000 91 13.2 – ADDENDUM NO. 2

- A. Project Name: Pacific Building Conversion
- B. Owner: Kitsap County Department of Human Services
- C. Architect: Rice Fergus Miller, Inc.
- D. Architect Project Number: 2021056.01
- E. Date of Addendum: November 29, 2023

STORM, GRADING & UTILITY PLAN

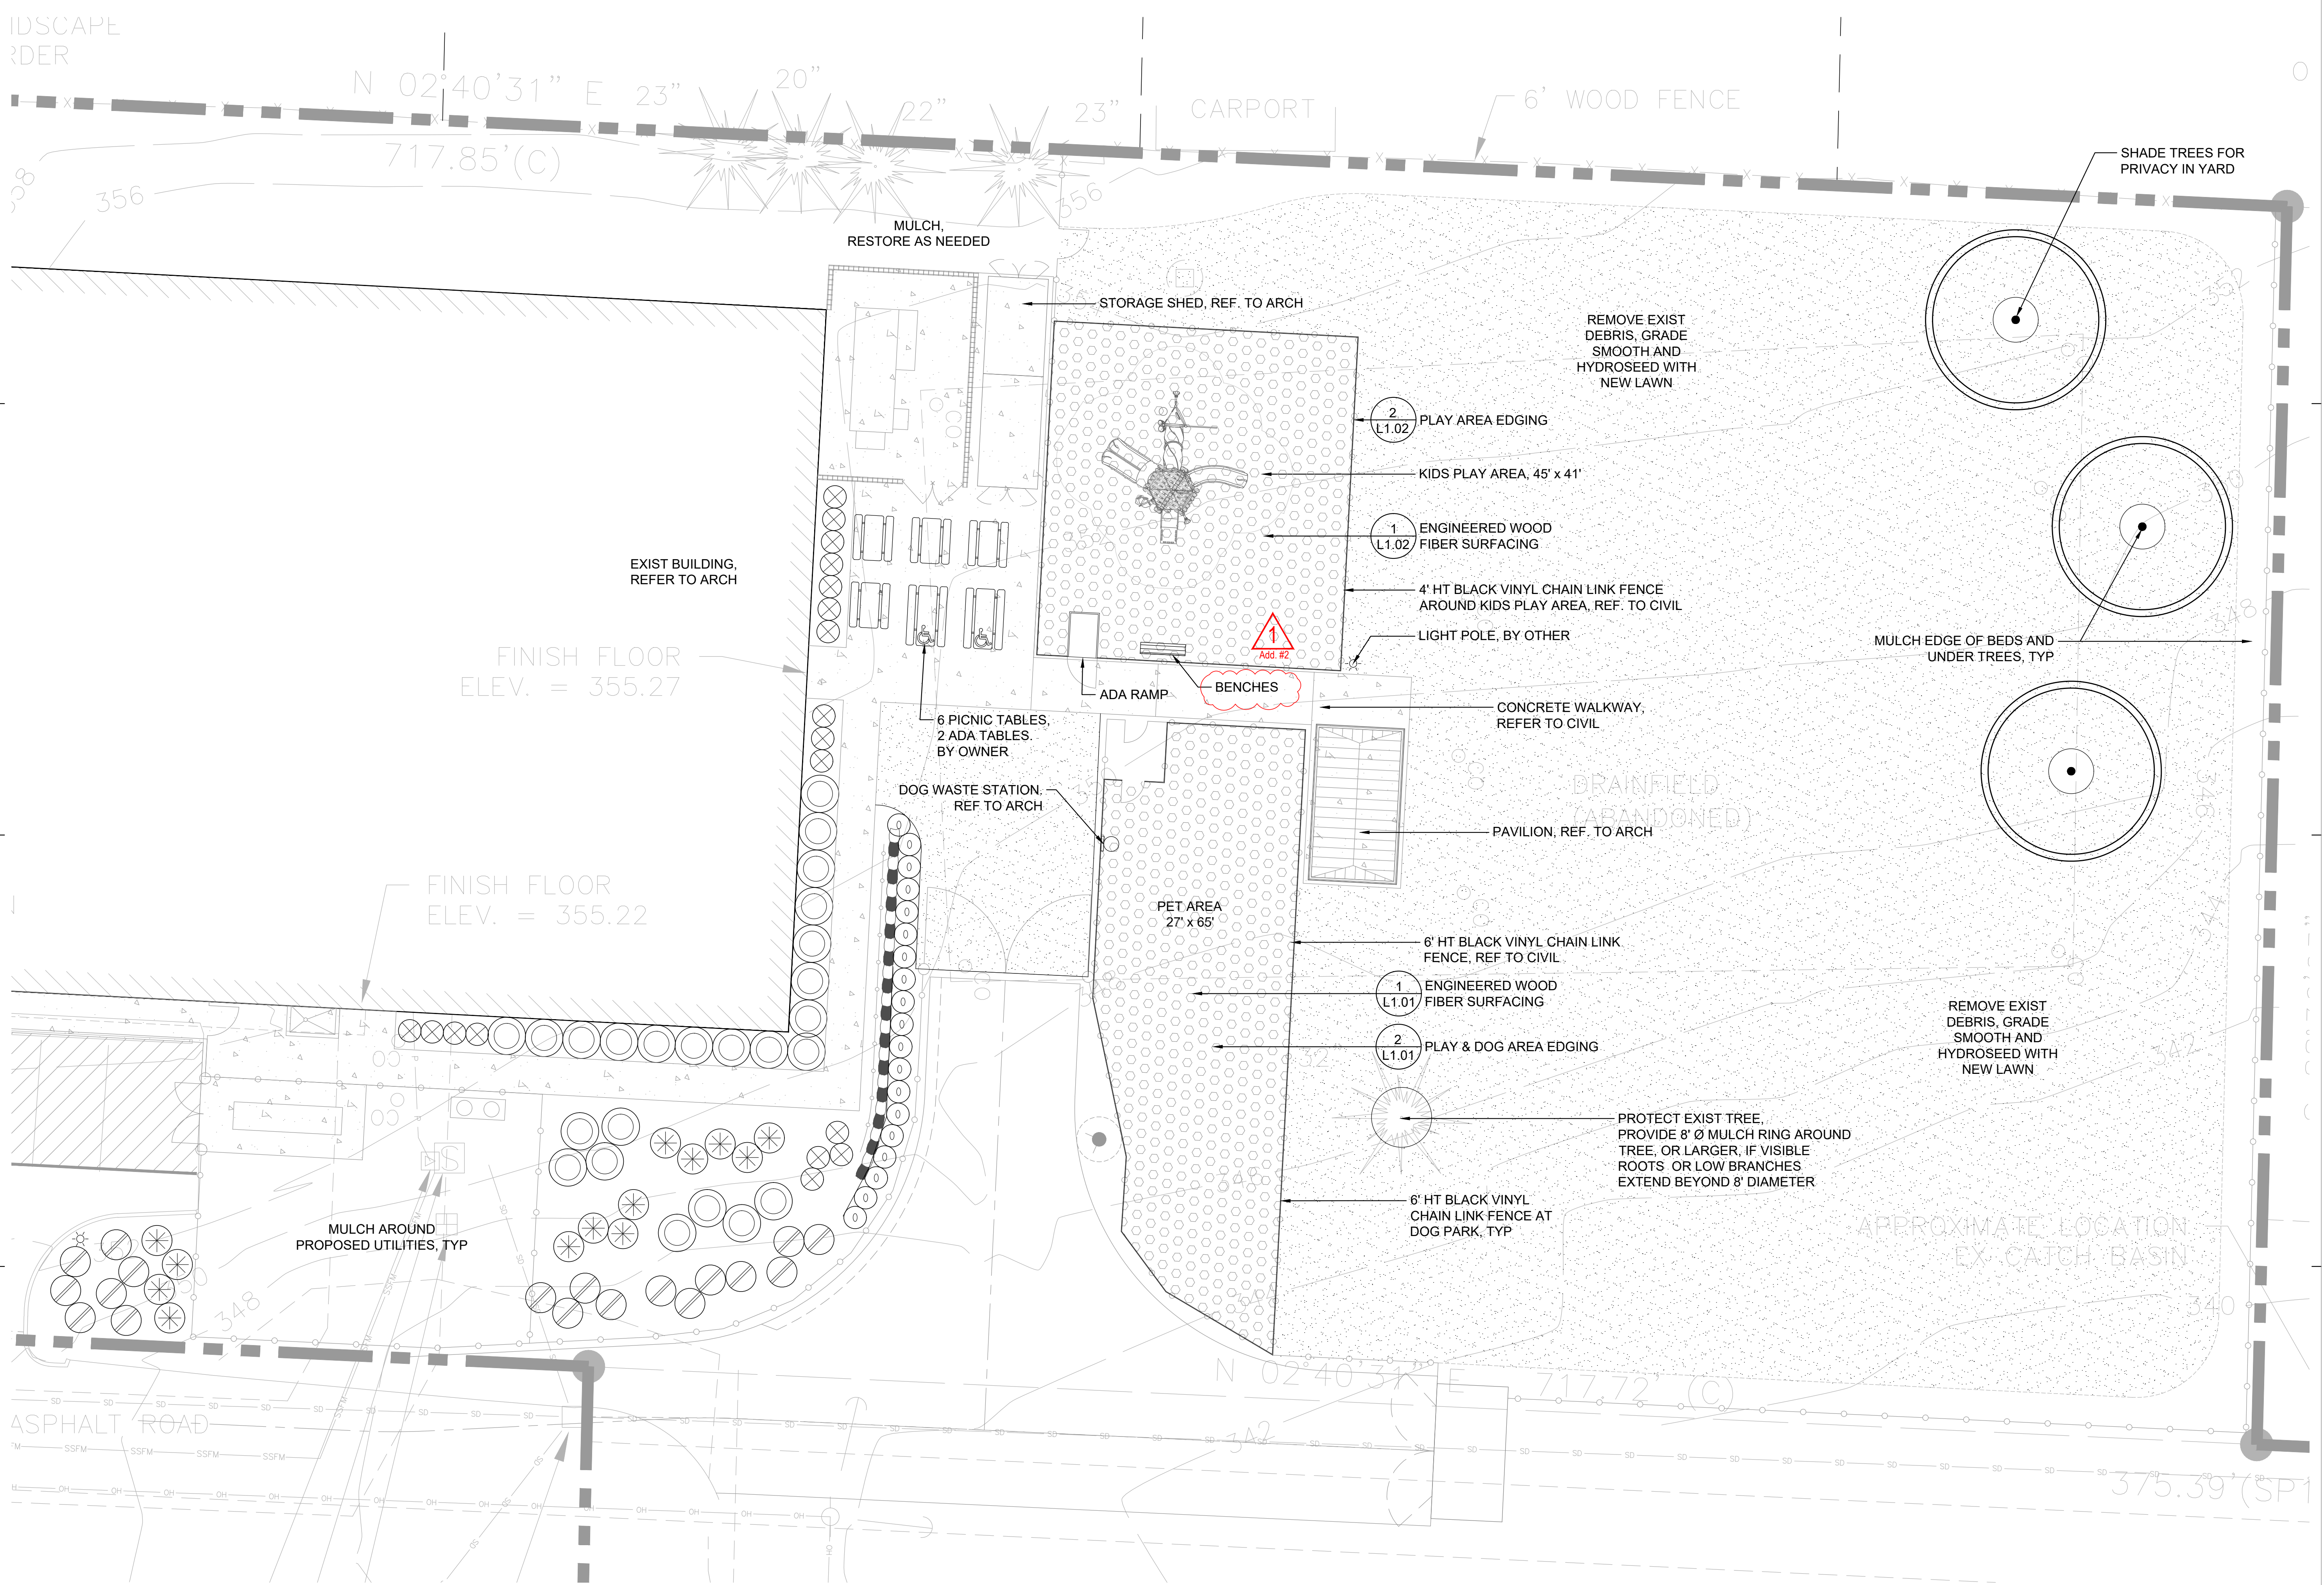
- ITEM 1. Sheet C3.00 – REPLACE in its entirety:
 - a. Removed “4” from bike rack note. The bike rack is existing.
- ITEM 2. Sheet C5.00 – REPLACE in its entirety:
 - a. Added notes indicating new roof drains, downspouts, and roof drain systems.
- ITEM 3. Sheet A00.01 – REPLACE in its entirety:
 - a. Revised project team contact information.

- Q11. Are we preserving the existing drain field for future use?
- A1. No. See Sheet C5.00 indicating "DRAINFIELD (ABANDONED)".
- Q12. Is there any expectation for exterior electrical for the future kitchen needs?

1 ARCHITECTURAL SITE PLAN
1" = 30'-0"

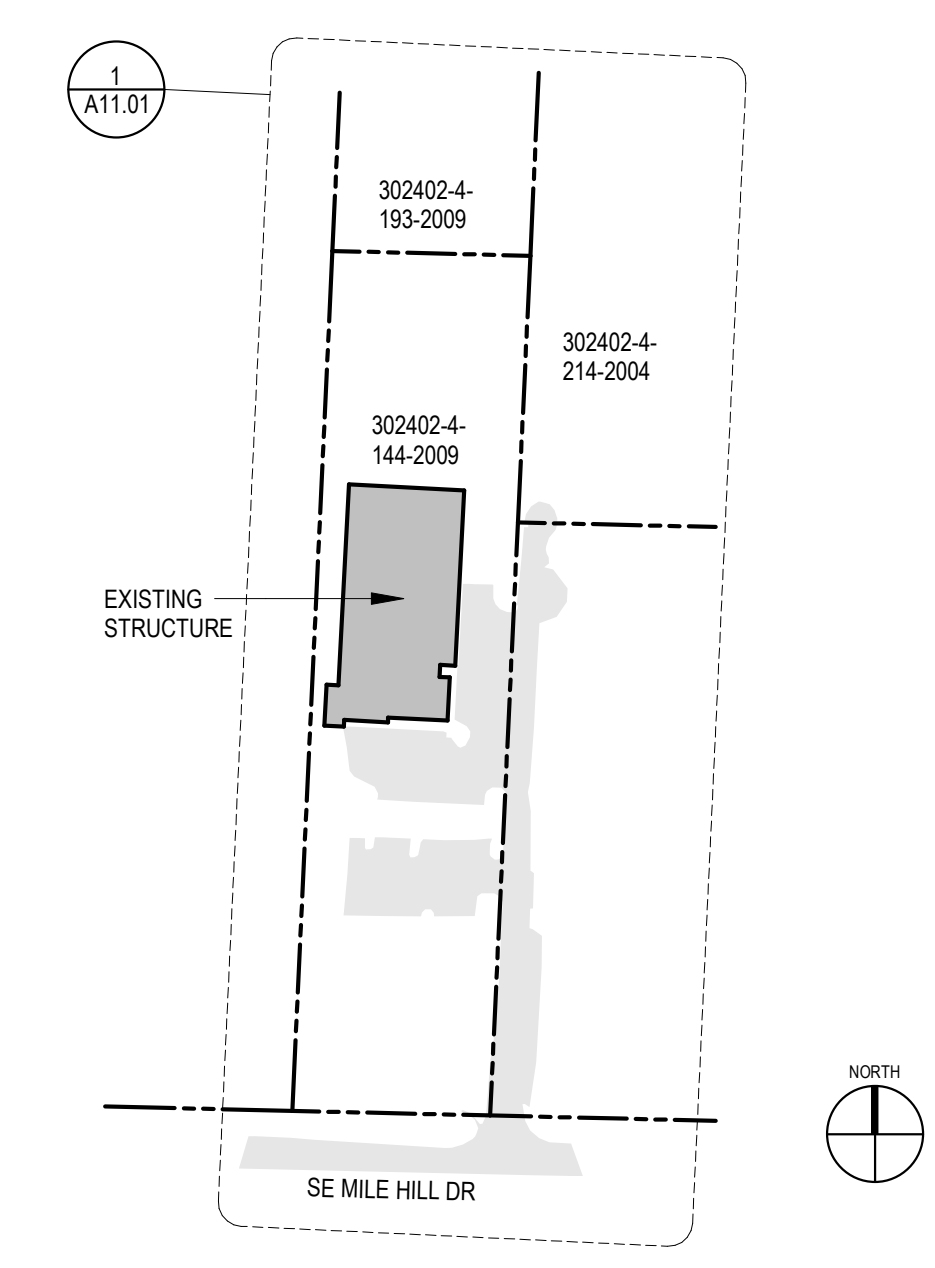
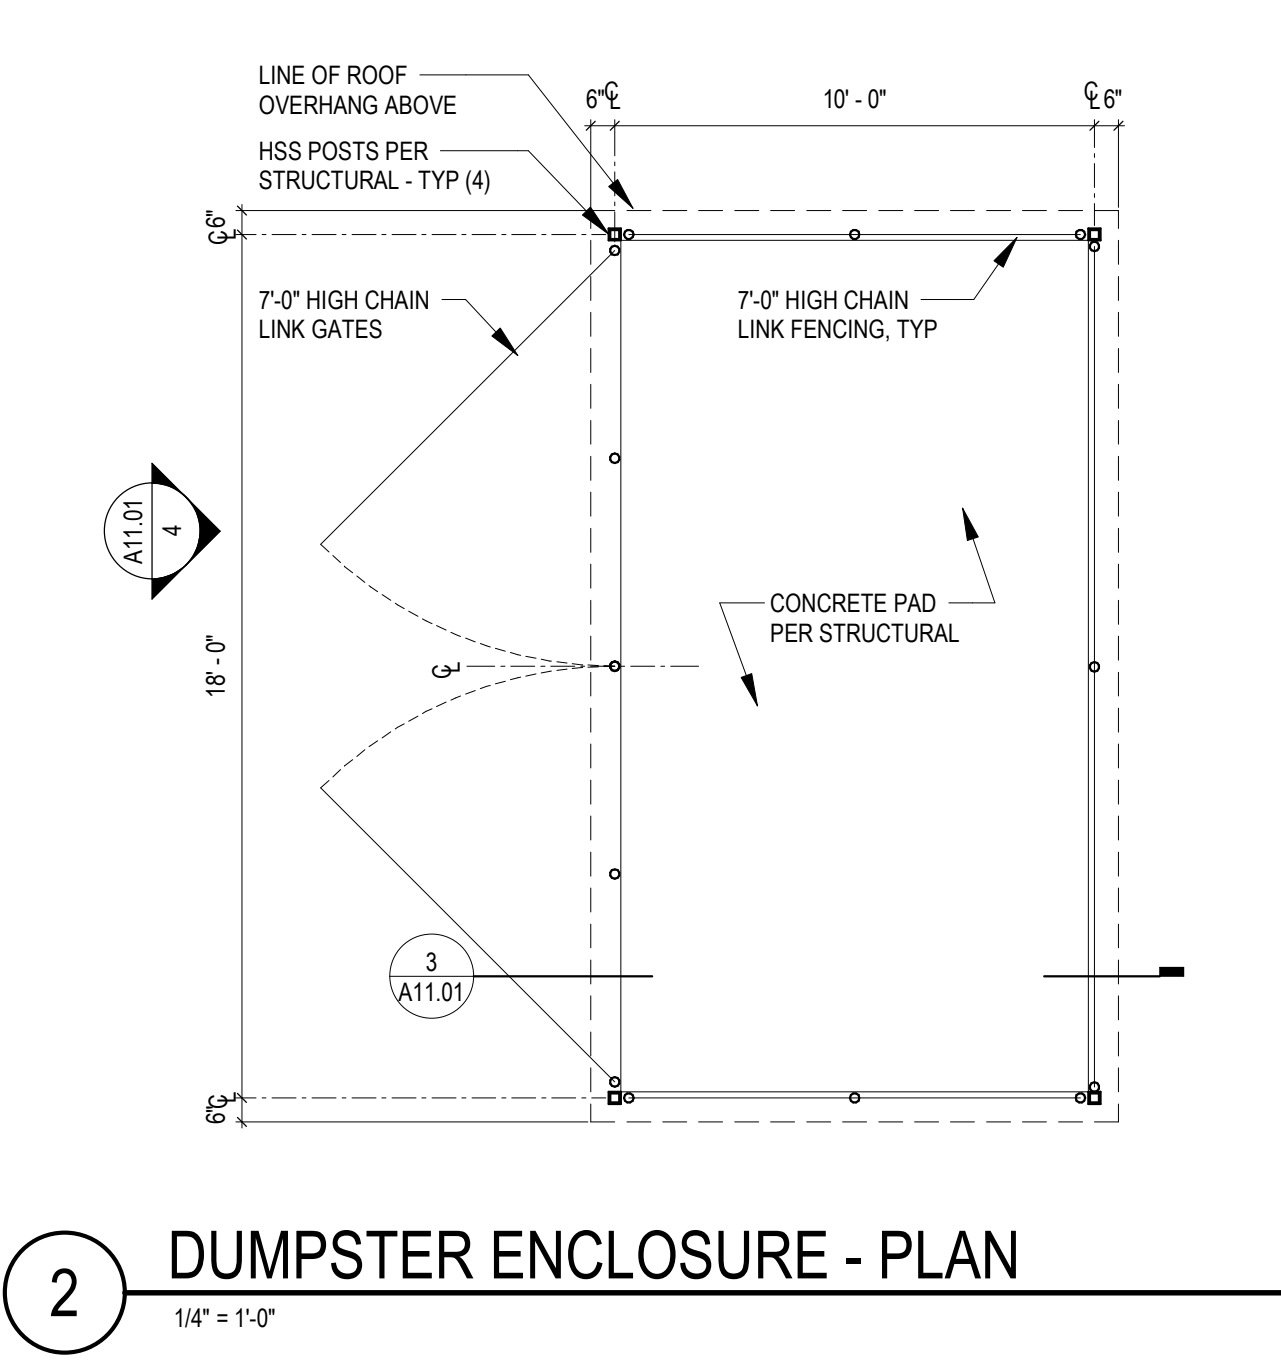
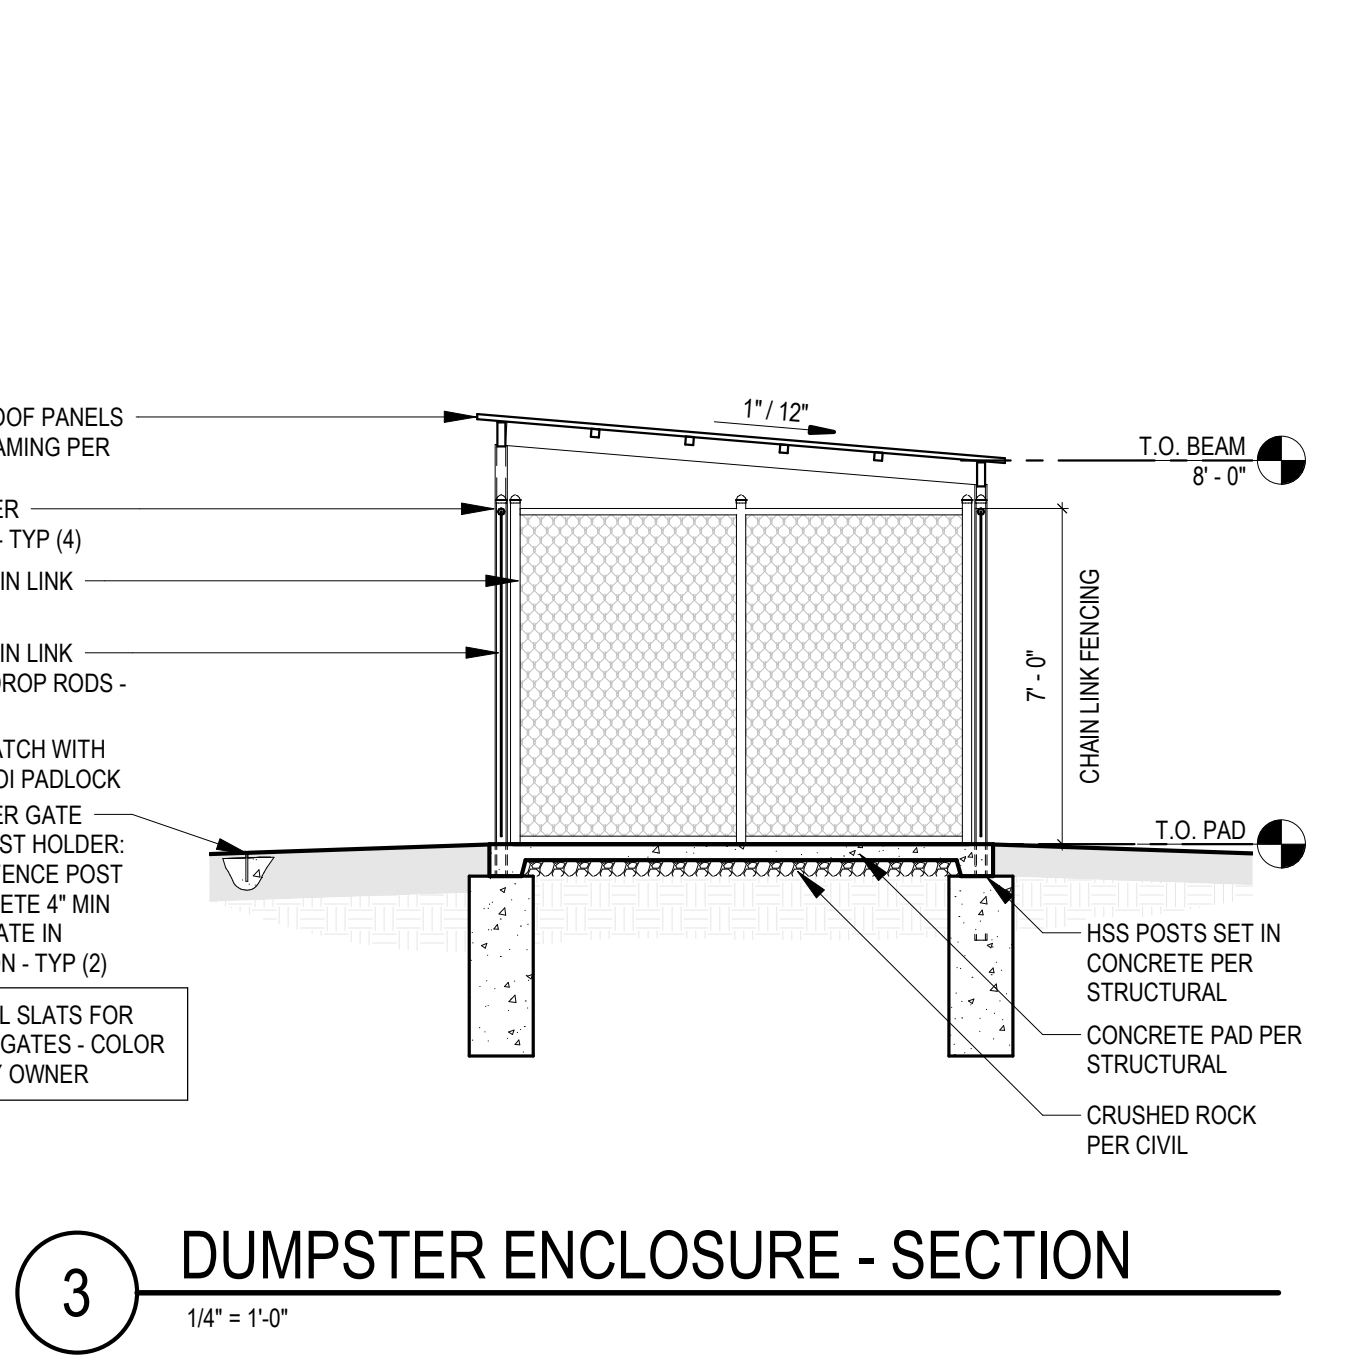
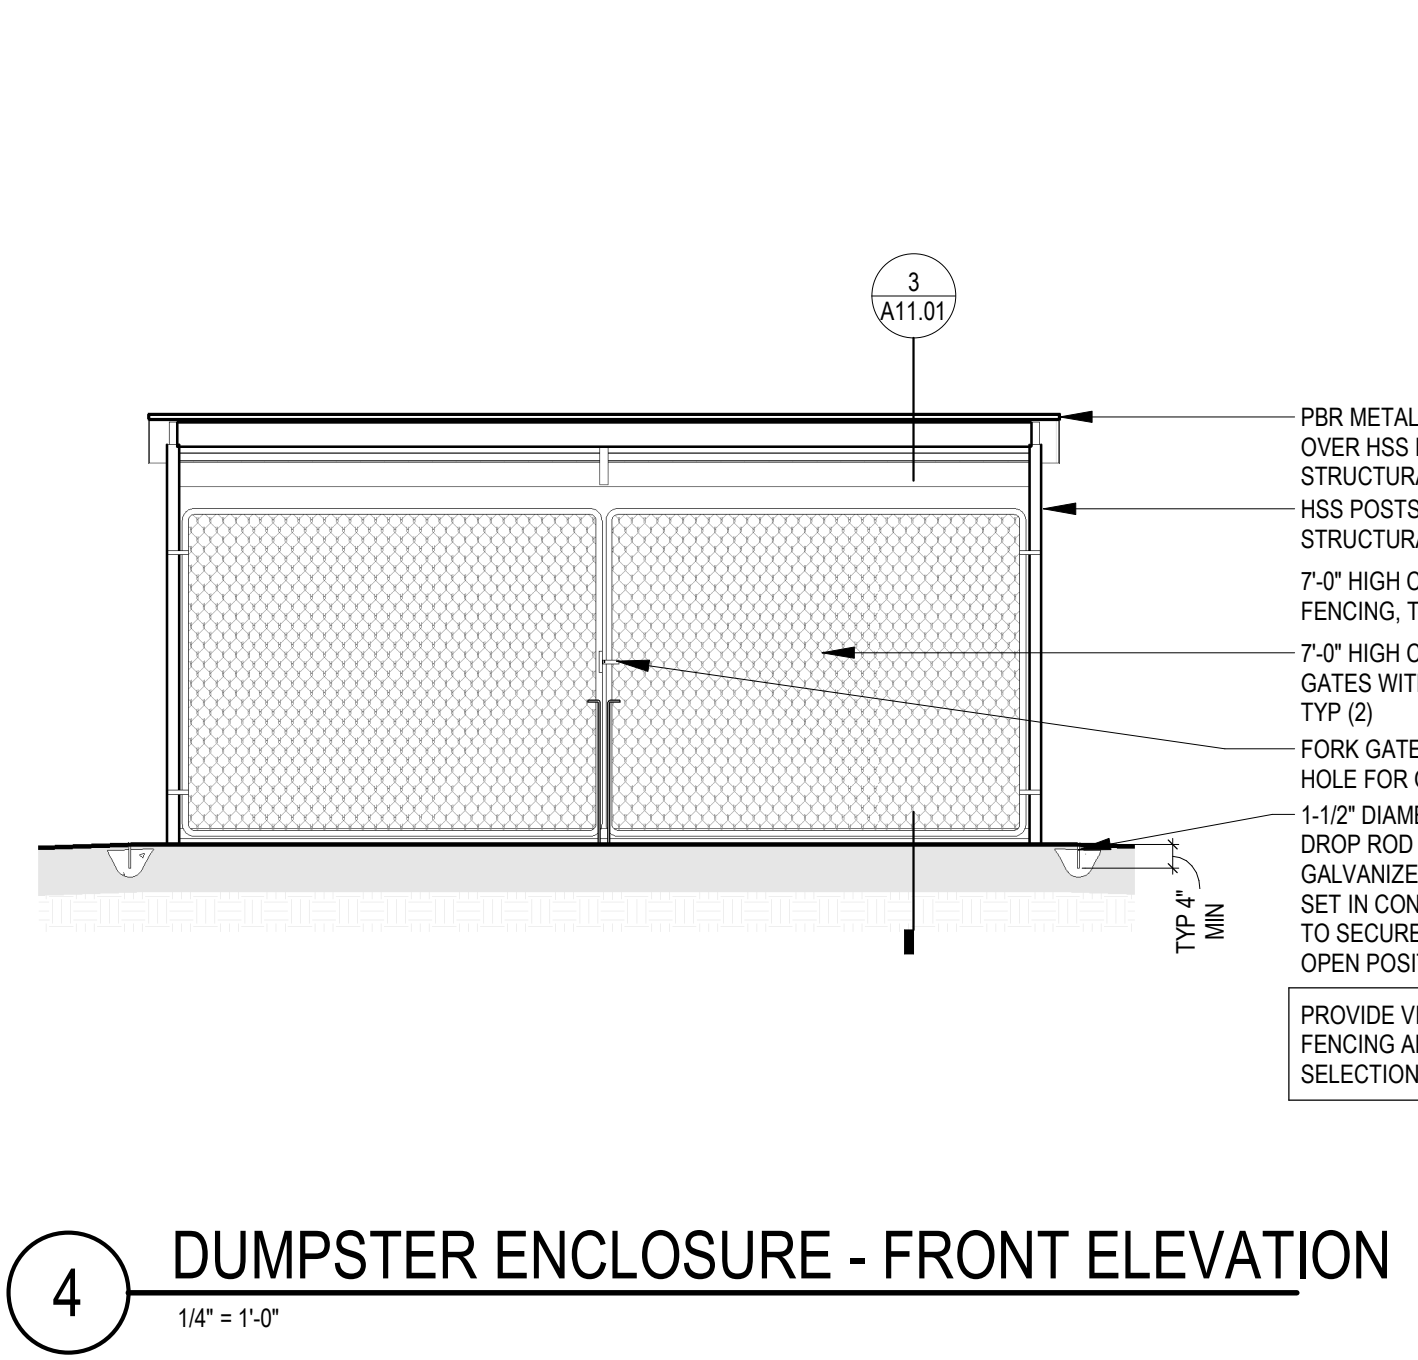
- ITEM 4. Sheet A11.01 – REPLACE in its entirety:
- a. Removed “4” from SITE-7 bicycle covered shelter note. The bike rack is existing.
- ITEM 5. Sheet A21.01 – REPLACE in its entirety:

- Q18. Section 32 33 00 SITE FURNISHINGS – Site furnishings are indicated on Sheets L1.01; A11.01; A81.01 and S4.25. Site 7 Bicycle Covered Shelter is CFCI, however the note on detail 8 on S4.25 states Bike Shelters by others. It also states that the Contractor is to verify structural stability. Please confirm that the GC should add Engineering Costs to purchase a specified structure. In the specification SITE 7 has the capacity of 8 bikes, yet A11.01 calls out a bicycle capacity of 4. Please clarify.

- A1. Yes – Bidders should include Engineering Costs for Site-7 bicycle covered shelter.
- A2. Removed "4" from bike rack note on Sheet C3.00 and from Site-7 bicycle covered shelter note on Sheet A11.01. The bike rack is existing equipment with an 8-bike capacity.
